DEPARTMENT OF TRANSPORTATION

49 CFR Part 571

Federal Motor Vehicle Safety Standards;

Ejection Mitigation

Figure 1 – Effect of a Grab Handle on the Target Locations of a 1st Row Window.

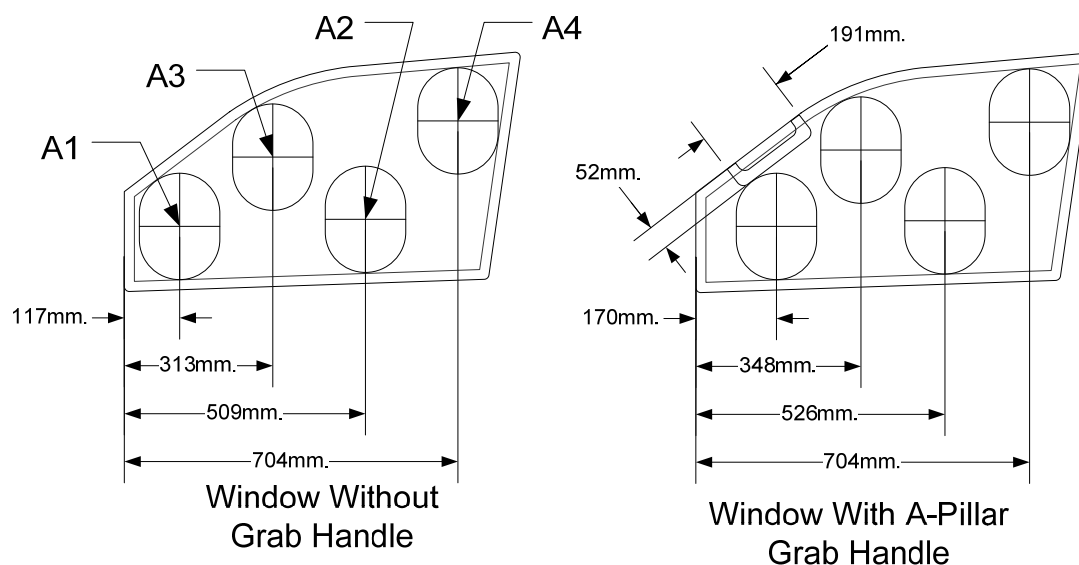
Moreover, we are concerned that the requested amendment would create a means to manipulate the test requirements, to enable designers to move the impactor away from weak points in the ejection mitigation countermeasure in a false way. Figure 1, below, depicts two renditions of a 1st row daylight opening. The illustration on the left shows the opening without a grab handle; the other shows a grab handle attached to the A-pillar. For convenience, we used an approximation of the target outline, rather than the exact cubic equation prescribed in the final rule. The target outline height and width are dimensionally correct relative to each other.

Reducing impactor displacement by means that would have real-world effectiveness in limiting occupant ejection is wholly appropriate. However, the Figure 1 example shows that by adding a grab handle to the A-pillar of a 1st row window opening, the stringency of the standard may be reduced by the presence of an item that, in a real-

Figure 2 – Graphic provided by ASC, showing a daylight opening with no top right-hand corner.

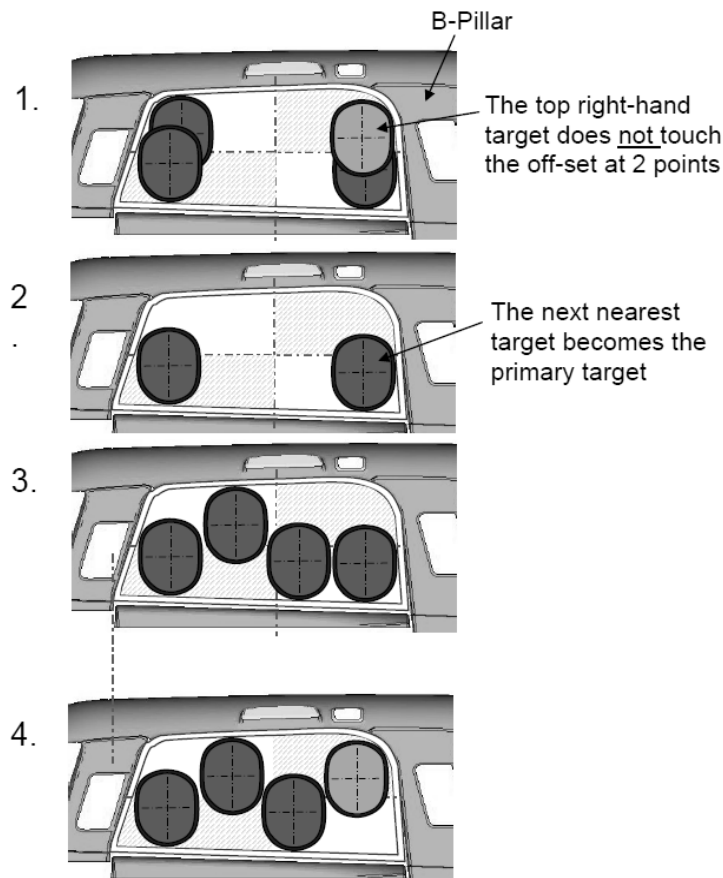
ASC asks for clarification of the targeting procedure for a window opening with a large radius, regarding the forward-upper quadrant of the daylight opening. It asks how NHTSA will position a target at the “corner” location(s) for this area of the window (top image (labeled “1”) in Figure 2, below.). ASC states that if the procedure is followed as written, the target would only contact the daylight opening offset-line at one point and, therefore, this quadrant would not contain a target. ASC states that S5.2.3.3 then specifies that the forward lower target would become the new primary target (image labeled “2” in Figure 2). ASC states that continuing with the specified test procedure, the selected targets would be as illustrated in the image labeled “3” in Figure 2. ASC believes that NHTSA intended the targets to appear as shown in the image labeled “4” rather than image 3 and asks for clarification of the procedure to achieve the target layout shown in image 4.

ASC is correct that the procedure of S5.2.3 results in the layout shown in image 3 in Figure 2. However, it was not our intent that the test procedure must specify placement of a target in the forward-upper quadrant of the window opening no matter the shape of the daylight opening. We believe that the absence of a corner in the forward-upper quadrant is not typical, so the final placement of the targets in the example shown is also not typical. NHTSA has not encountered a situation like this in any vehicle we tested.

Figure 3 (Figure “5a” in regulatory text)

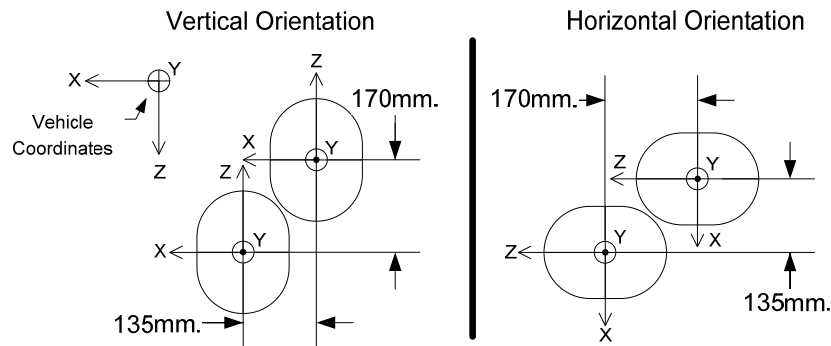
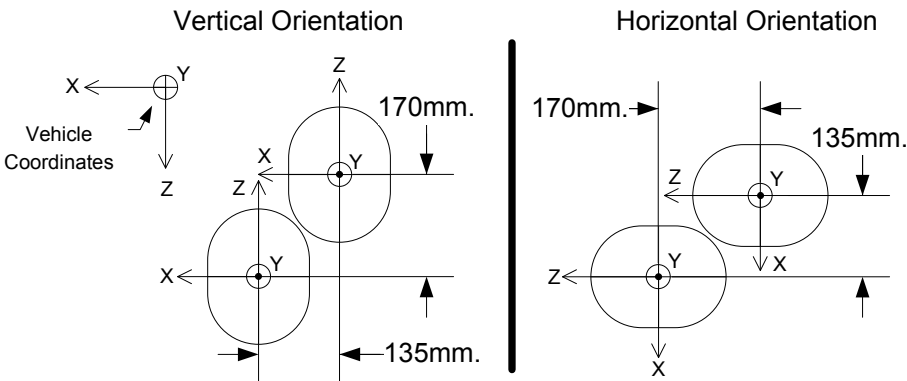
The Alliance believes that the reference coordinate axes used throughout the regulation, and particularly in S5.2, need illustrations and/or figures to better define the vehicle, headform and target axes, especially with rotation of the headform. TRW and ASC ask for clarification of S5.2.5.1.1 as to the specified distances between the target's local z-axis and x-axis, i.e., whether the distances remain constant irrespective of target orientation. Both the Alliance and ASC provide figures to illustrate their understanding of S5.2.5.1.1 and S5.2.5.2 and ask if their understanding is correct. They suggest that figures be added to the regulatory text to help clarify the relationship between vehicle and target axes when assessing possible target elimination.

We are granting this request. The figures submitted by the Alliance, TRW and ASC correctly interpret the regulatory text in S5.2.5.1.1. We agree that adding figures to the regulatory text would be helpful. We are adding the figures below to the regulatory text as new Figures 5a and 5b. Figure 3 below (new Figure 5a in the regulatory text) shows the vehicle and target coordinate systems from the perspective of a viewer facing the left side of the vehicle exterior. The minimum distance of 170 mm and 135 mm between the x and z axes, respectively, are also shown. The left side of the figure shows these minimum distances for vertically-oriented targets and the right side of the figure shows these for horizontally-oriented targets. Additionally, the right side of the figure provides the orientation of the z axis of the target specified in S5.2.5.2.

Figure 6 – Maximum overlap of targets under various scenarios.

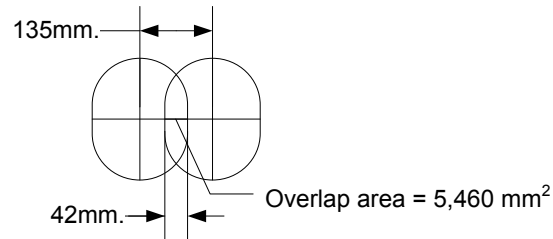
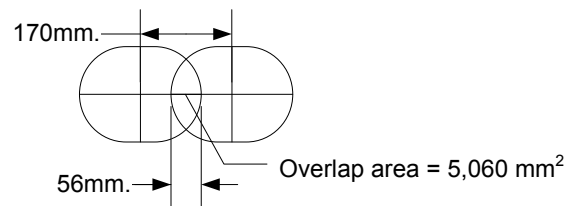
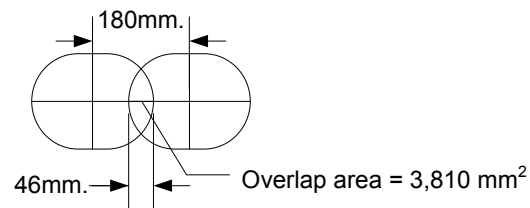
We decline to increase the 360 mm distance for horizontally-oriented targets.³² There is a potential for three horizontal targets to represent the final target locations under provisions of S5.2.5.2. The question presented is whether the overlap of the horizontal targets is excessive compared to the overlap “permitted” by the standard for vertical targeting configurations. To help in this assessment we have constructed Figure 6, below. This figure shows the maximum allowable overlap of targets under three different scenarios.

Example 3 is the situation for which ASC suggests the agency should make some form of accommodation to reduce the potential overlap. However, we see that, when compared to Examples 1 and 2, Example 3 has a smaller area of overlap than Examples 1 or 2 and less linear overlap than Example 2. The maximum potential overlap under S5.2.5.1.2 for horizontal targets is, in fact, less than the maximum potential target overlap for other target configurations. All-in-all, we do not believe that these targeting scenarios allow for excessive overlap. The targeting procedures ensure that the ejection mitigation countermeasure is evaluated throughout coverage of the daylight opening. Accordingly, because we do not believe the overlap allowed for horizontal targets by S5.2.5.1.2 is excessive, we see no reason to limit it further.

Note that the maximum amount of overlap is achieved when a target axis of a target is aligned with that of another. In the three scenarios of Figure 6, the horizontal axes are aligned. Example 1 shows the maximum overlap for vertically-oriented targets under the provision of S5.2.5.1.1.³³ The linear overlap of these targets is 42 mm and the area of overlap is 5,460 mm². Example 2 shows the maximum overlap for horizontally-oriented targets under the provision of S5.2.5.1.1. The linear overlap of these targets is 56 mm and the area of overlap is 5,060 mm². Example 3 shows the maximum overlap

Figure 7
(Showing Figure 16 in NPRM)

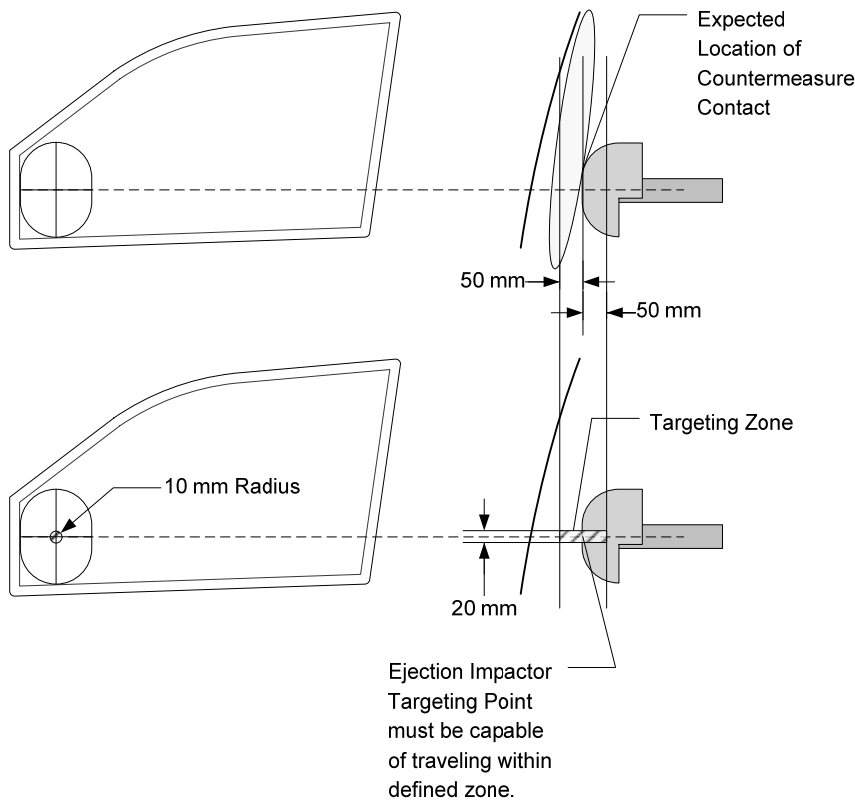
As shown in Figure 16, a zone could be established by first determining the “ejection impactor targeting point,” the intersection of the x- and y-axes on the outer surface of the headform. Next, the location of first contact between the impactor and the ejection mitigation countermeasure (e.g., ejection mitigation air bag curtain) would be determined, based on the location of the target outlines using the methodology in the compliance test specified for identifying the target outlines. A 100 mm wide zone would be determined by defining two vertical longitudinal planes that are 50 mm on either side of the expected location of contact by the impactor with the countermeasure. These longitudinal planes define a portion of the strike zone. The other portion of the zone would be

We are granting the request to revise S7.4. The Alliance is correct that the zone specified in S7.4 is a cylinder with a 10 mm radius. However, “D” does not represent the line segment that the cylinder is centered around. Rather, “D” was intended to be a point of reference for the theoretical point of contact with the countermeasure. In response to the Alliance’s comment that vertical and longitudinal planes cannot be defined in vehicle coordinates as forward and rearward of a lateral segment, the terms “forward” and “rearward” in S7.4 were intended to be in reference to the impactor’s direction of travel, not the vehicle coordinate system.

After reading the Alliance’s petition, we have revised S7.4 solely for purposes of clarifying it. No substantive change is intended. Among other things, we have rewritten S7.4 to indicate the cylindrical nature of the zone of interest and to eliminate the reference to distance “D,” since the reference to D was confusing to the petitioner.
